Holmes Miller

Holmes Miller (HM) were instructed by CEC on 6 January 2026 to proceed with a Feasibility Study looking at:

1. Dining and Social space
2. External Space Generally
3. Community Room on Lower Ground Floor
4. Dual Classroom Space 3.03 and 3.19

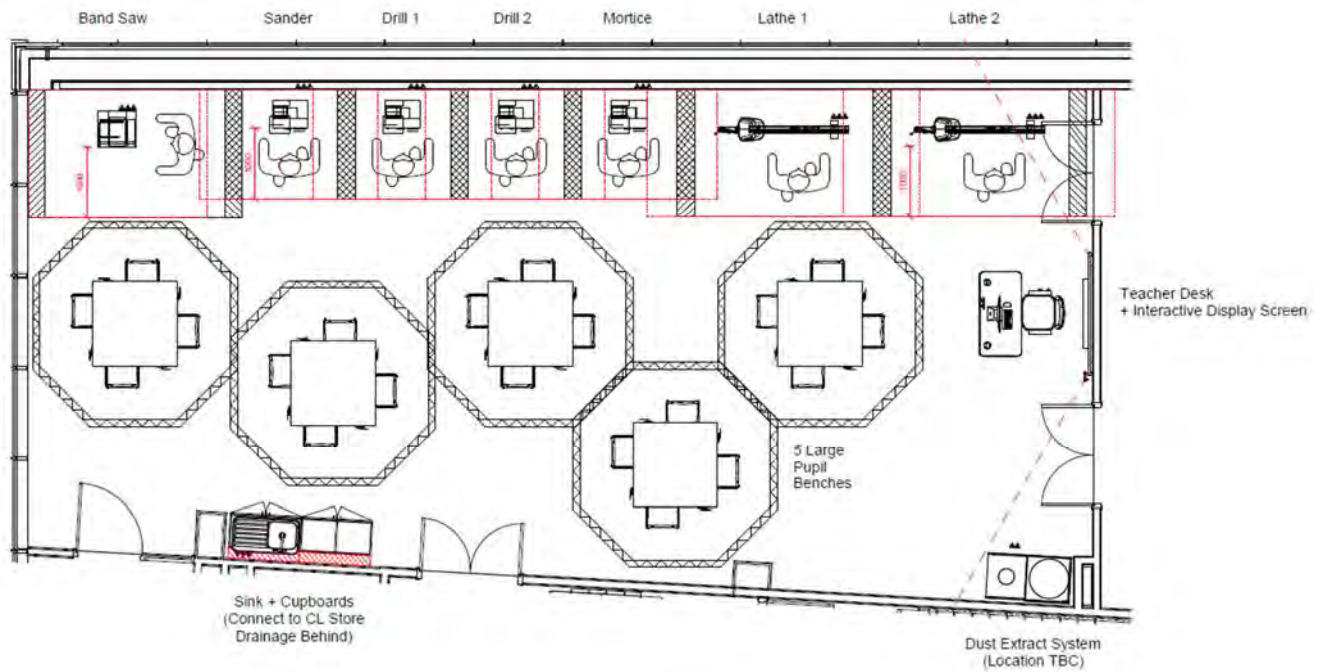
1.4 During a site visit it was noted that a section of the glass balustrade was cracked, indicating use of toughened laminated glass anticipated. HM confirmed balustrade of this type generally have a degree of flex. HM advised that raising the height of the balustrade would likely require complete replacement of supports and that the additional load would impose additional loads on the structure that a structural engineer would need need to assess and advise if they could be accommodated. The consensus was that this was a FM / maintenance issue for CEC to address.

4 Dual Classroom Space 3.03 and 3.19

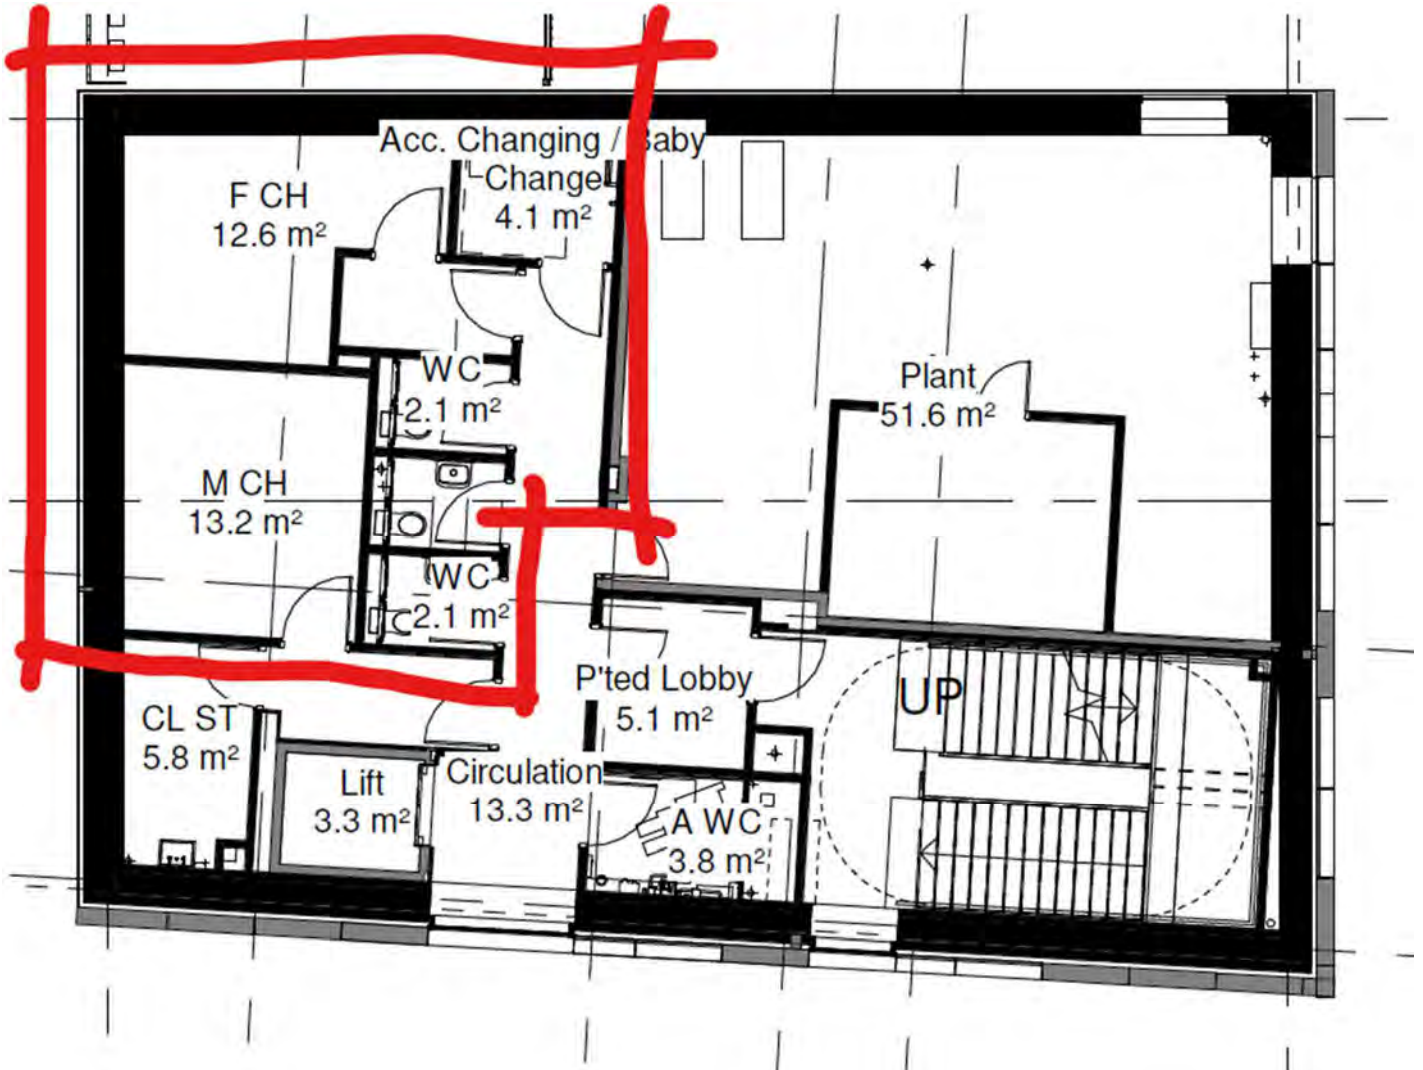
4.1 BHS advised that the acoustic partition between the two teaching spaces provided inadequate acoustic separation when in closed position, compromising teaching.

The partition dividing the two teaching spaces appears to be a suitable / appropriate sliding folding partition. HM identified the partition manufacturer from details on the partition, manufactured by Espero and through them were able to identify the installer as Style Group.

Style Group (contact - [REDACTED]@style-group.co.uk, [REDACTED]) confirmed that they had installed the partition in 2017 and they should provide a 55dB rating. Style Group noted that there was no record of any annual maintenance being carried out and it may be that the panels are not being aligned correctly which can affect the acoustic properties. Also advising that the "seals need to be fully wound as this is what seals the panels at the head and base and then the telescopic panel also has the seal to the wall". No information on maintenance or O&M manual appeared available for use.

An O&M manual for the Espero Sonico partition was obtained and circulated. CEC should ensure this is followed and may want to consider maintenance.

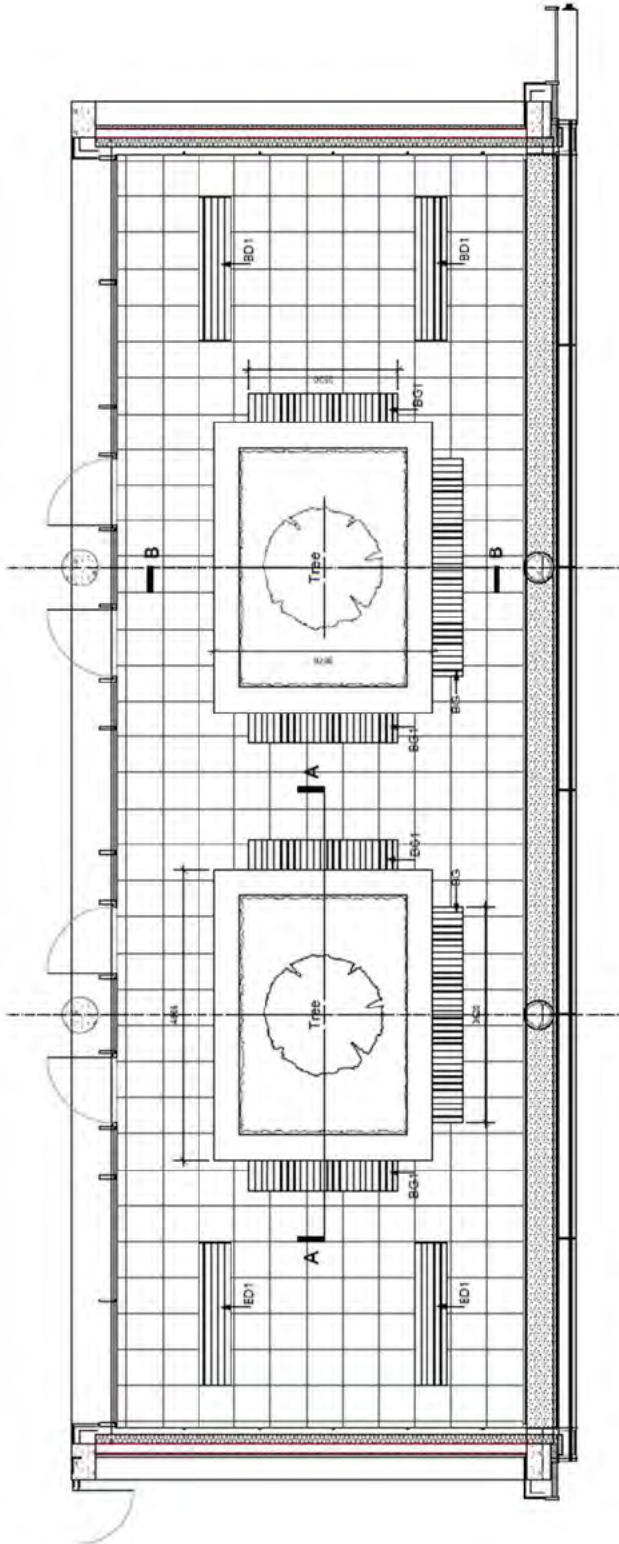
- 5.1 BHS raised enclosing the rooftop MUGA. HM advised that the structure would not have been designed for the addition loadings, wind etc., that enclosure would entail. BHS asked if the MUGA area could be increased. CEC advised that plant / plant access routes would restrict this. CEC confirmed no further action for HM on this issue
- 5.2 BHS sought clarity if the changing area above the new technical teaching space could be repurposed.

HM advised a brief for this would be needed and additional work, increase in scope of study, carried out to establish if this would be feasible.
